MEMORANDUM

From:	Catherine Brimble Senior Landscape Officer		
Service	SDL Landscape and Trees	App No:	242696
Address:	Hogwood Farm, Sheerlands Road, Arborfield, Wokingham, RG40 4QY.		
Proposal:	Application for approval of Reserved Matters pursuant to Outline Planning Consent O/2014/2179 (as varied by 181194, dated 14/11/2018). The Reserved Matters comprise details of sports pitches, sports pavilion, allotments, car parking and play areas; along with associated landscaping, highways and drainage infrastructure. Details of access, appearance, landscaping, layout and scale to be considered		
Type of Development:	Major All other developments		
Site Visit Made:	Yes/No

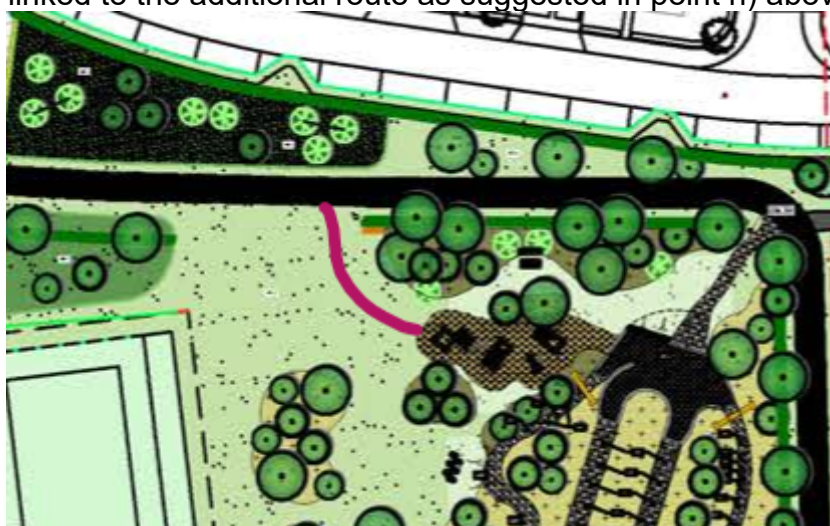
- j) I still suggest there should be an informal path linking the bridleway to the north of the play area / BMX track to this area as indicated below by a purple line, as it is likely a desire line will be created into this area. The path can be linked to the additional route as suggested in point h) above.
